## Product Change Notification / ASER-13KWIQ013

CCB 4978 Final Notice: Qualification of MMT as an additional assembly site for selected ATSAME5xxx and ATSAMD5xxx device families available in 128L TQFP (14x14x1mm) package.

**CCB 4978**  
**Pre and Post Change Summary**  
**PCN #: ASER-13KWIQ013**

# Lead Frame Design Comparison

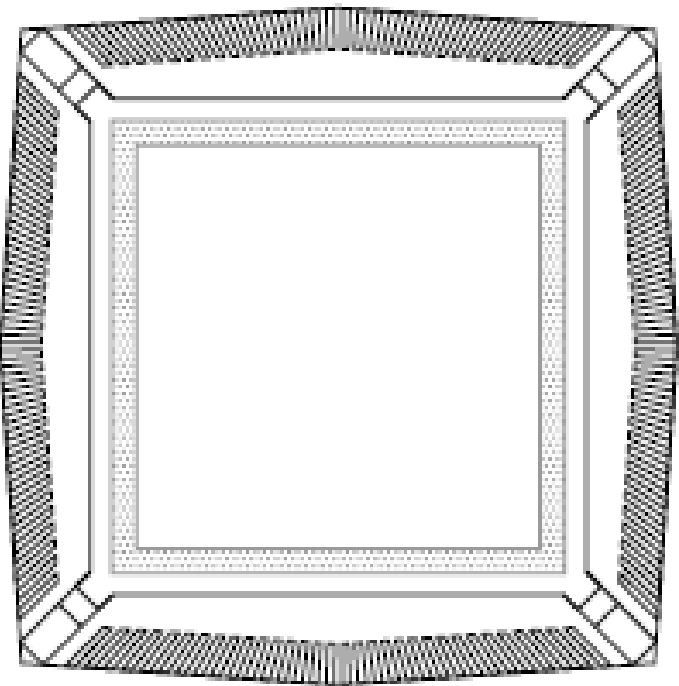
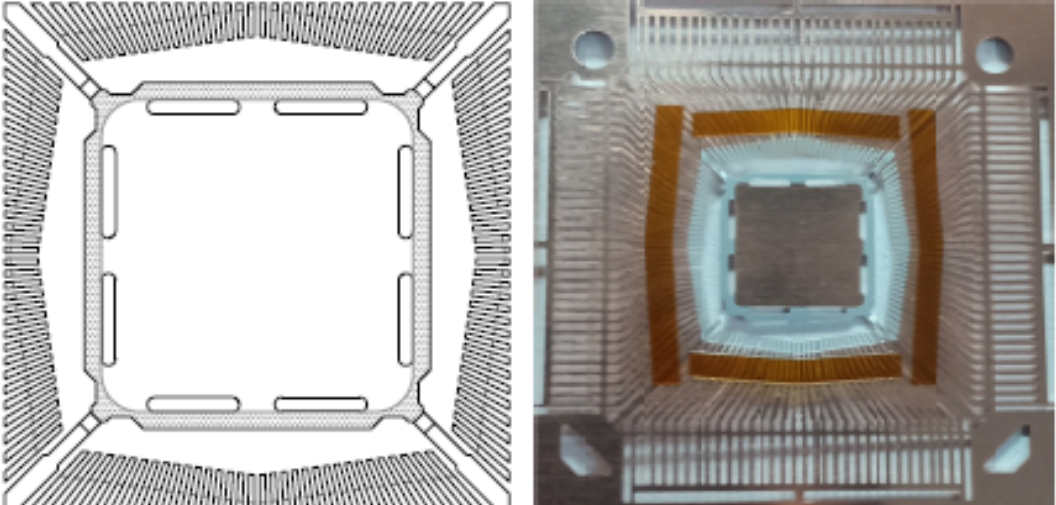
ASE	MMT				
 <p>A technical drawing of an ASE lead frame. It features a square central cavity surrounded by a thick, multi-layered frame. The frame has a complex, textured appearance with many small rectangular features along its perimeter. The corners are rounded.</p> <table border="1" data-bbox="484 1153 1026 1239"><tr><td>Paddle Size</td><td>240x240 mils</td></tr></table>	Paddle Size	240x240 mils	 <p>Two images of an MMT lead frame. On the left is a technical drawing showing a square central cavity with a frame that has a distinct, stepped profile. On the right is a photograph of the actual lead frame, showing its metallic, reflective surface and the square central opening.</p> <table border="1" data-bbox="1574 1153 2117 1239"><tr><td>Paddle Size</td><td>190x190 mils</td></tr></table>	Paddle Size	190x190 mils
Paddle Size	240x240 mils				
Paddle Size	190x190 mils
